OFFICE OF THE
TOWN PLANNER

Re: TRC Variance Recommendations (Consent Agenda Items)

Lincoln Memorial School Redevelopment
Comprehensive Permit - Master & Preliminary Plan
TRC Report

Lonsdale Minor Land Development –Preliminary Plan
AND
Change of Zone Request from RL-9 to RG-7
TRC Report

Site Plan

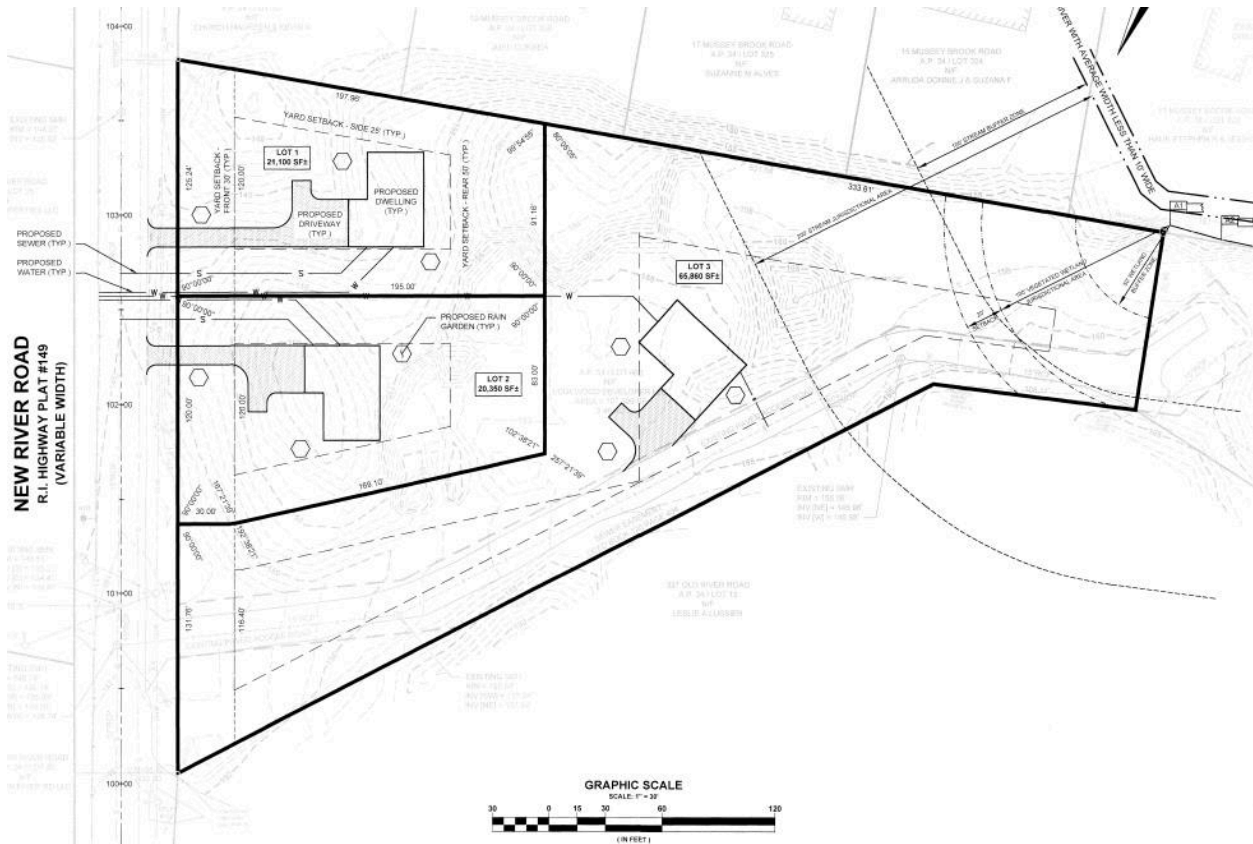
The zoning code establishes the dimensional regulations for lots for each respective zoning category. The subject property is zoned RS-20, which requires 20,000 SF of lot area and 120' of lot width *measured at the minimum front building setback line*. Lots 1 and 2 meet all of the dimensional requirements in RS-20 zoning. Lot 3 meets or exceeds all the other dimensional requirements, but is 3.6' shy of the required 120' lot width.

The Zoning Official expressed that he was not in favor of the requested relief because he believes that the applicant is creating his own hardship. Mr. Hervieux conveyed that the applicant could propose a two-lot subdivision and meet all of the dimensional requirements.

Other members of the TRC offered a different perspective. The DPW Director was in favor of the application on the grounds that the relief requested is very minimal in nature and would have no impact on the abutters or character of the area. The relief constitutes 3% of the 120' required for Lot 3 or 1% of the total 360' of width required over the 3 lots. The Town Planner also vocalized support of the application, stating that the irregularly shaped lot creates the unique hardship that could justify the relief. If the side lot lines were perpendicular from the right of

way, as Lincoln's regulations require, then the Lot 3 would exceed the minimum lot width requirement because the lot has 131.76' of width measured at the street frontage. It is only because the ordinance requires that the measurement be taken at the front setback line that the applicant is 3.6' short. It is the Planner's opinion that the intent of lot width regulations is to maintain the scale and densities in the neighborhood, therefore relief would not undermine the intent of the code as the subdivision would maintain (and exceed) the separation of buildings and density in RS-20. The Town Planner noted that the proposed use and density are consistent with the Comprehensive Plan's Future Land Use Map allocation of Residential Medium (1/4 – 1 acre lots) with an average lot size of 0.83 acres. The single-family development would be consistent with the land uses in the area.

Based upon the findings that the granting of the relief would be consistent with the Comprehensive Plan and the character of the surrounding area, would not undermine the intent of the zoning code and is minimal in nature, the TRC voted (4-1, Mr. Hervieux voted nay) to recommend that the Planning Board make a **positive recommendation** on this application to the Zoning Board of Review.

Site/Utility Plan (Sheet 2 of 3)

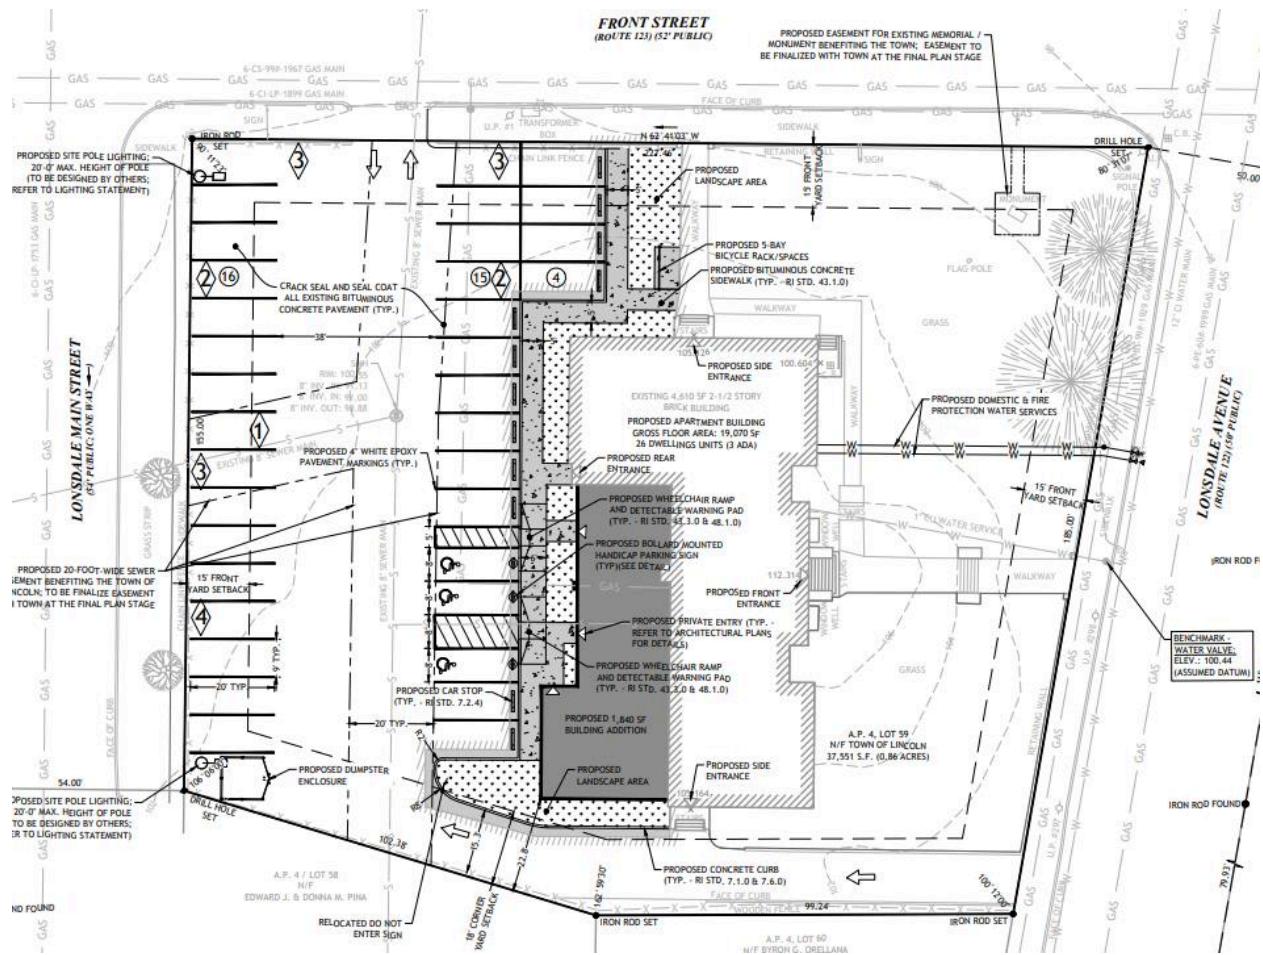
The applicant provides an impervious cover calculation on sheet 2 of 3 of the Civil Plan Set. The calculation demonstrates that there are 26,533 SF of existing impervious coverage and a proposed impervious coverage of 25,118 SF. Therefore, there is a proposed reduction in impervious surfaces by 1,415 SF. Because the applicant improving the existing conditions, the applicant is not required to provide addition stormwater mitigation.

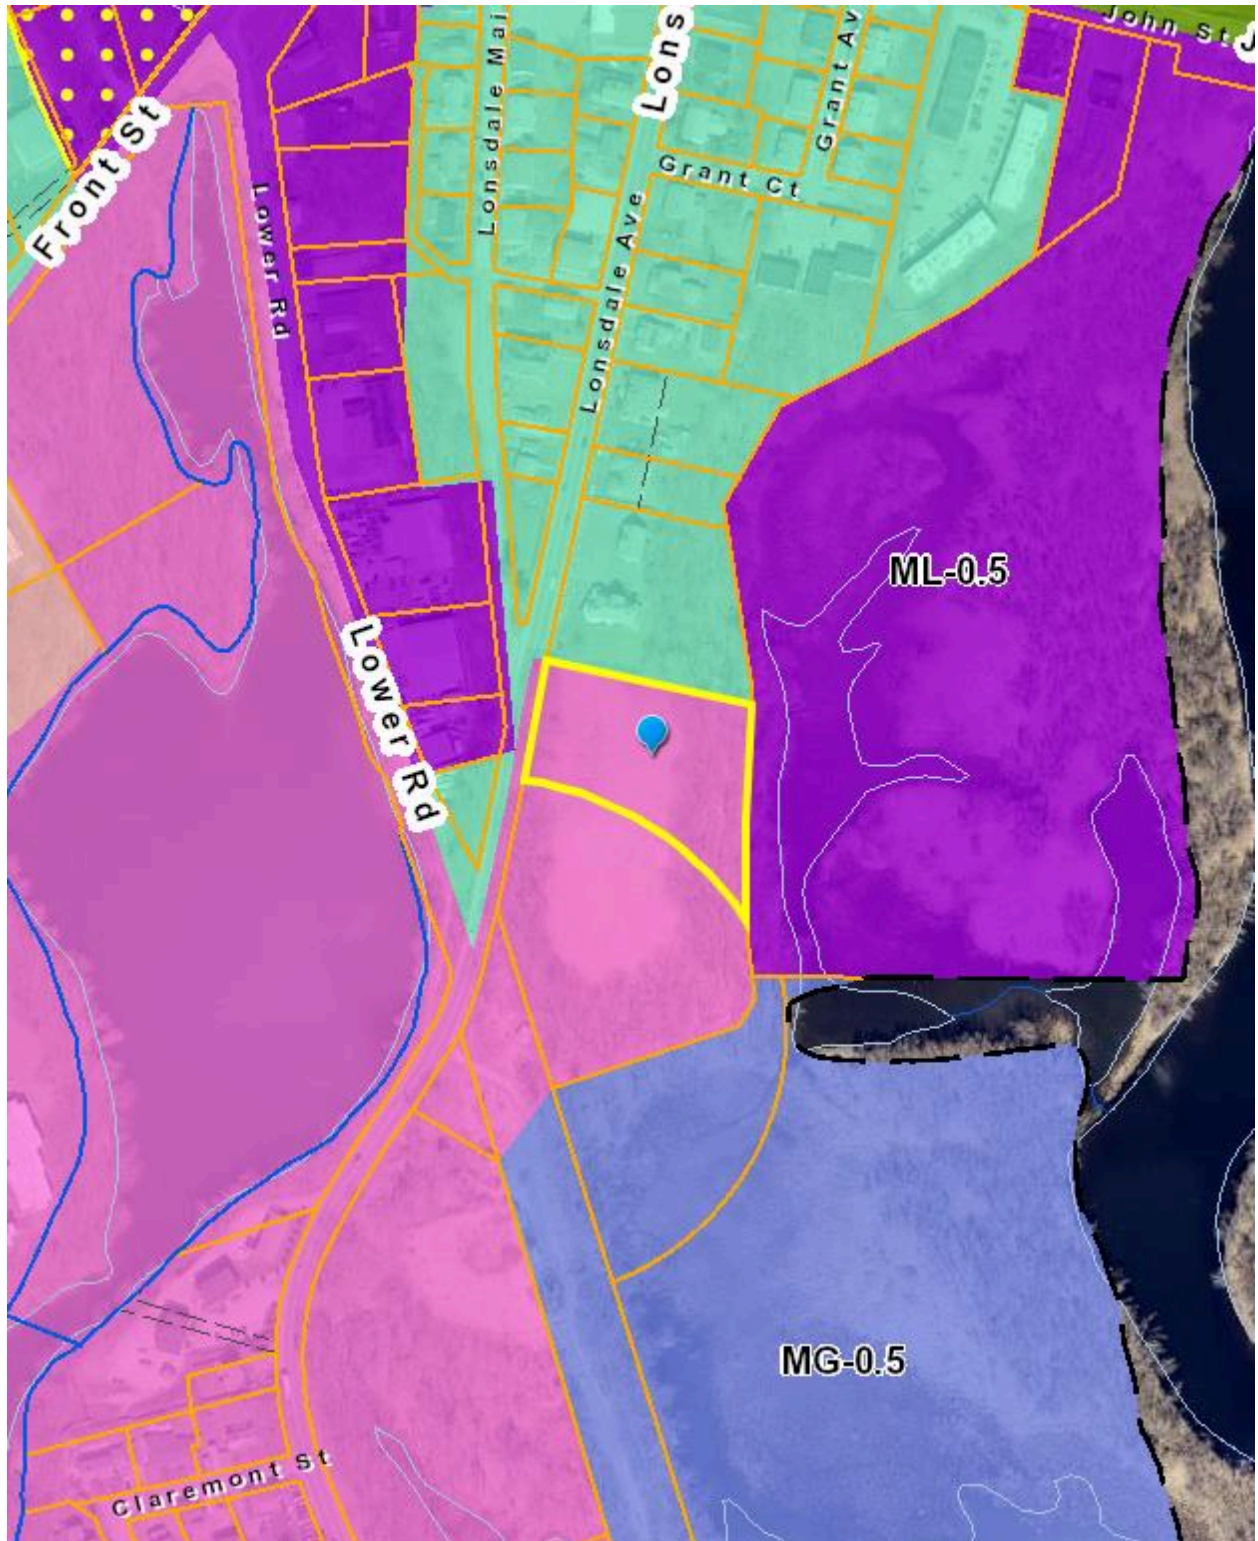
The Town Engineer has reviewed the stormwater and drainage patterns and recommends that groundwater recharge, water quality volume, and sediment forebay sizing calculations be provided. The applicant has been notified that **this must be submitted and reviewed prior to Preliminary Plan approval**. In addition, there was a concern regarding the location for emergency overflow as it would be preferred that the drainage basin overflow into the wetland rather than into the road. It should be noted that the applicant is not required to design beyond the 100 year storm, and that the DPW Director thought that it was fine as proposed, stating that if there was a storm event beyond the 100 year storm, that there'd be water everywhere. The TRC did not stipulate any specific condition on this issue, but asked that the applicant engage in further conversation with the Engineer to explore agreeable solutions to this potential problem.

Pending the submittal and satisfactory review of a wetlands report and groundwater recharge, water quality volume, and sediment forebay sizing calculations prior to the public hearing, the TRC unanimously voted (5-0) to recommend the Planning Board adopt the findings of fact and APPROVE the Lonsdale Minor Land Development preliminary plan application with the following conditions:
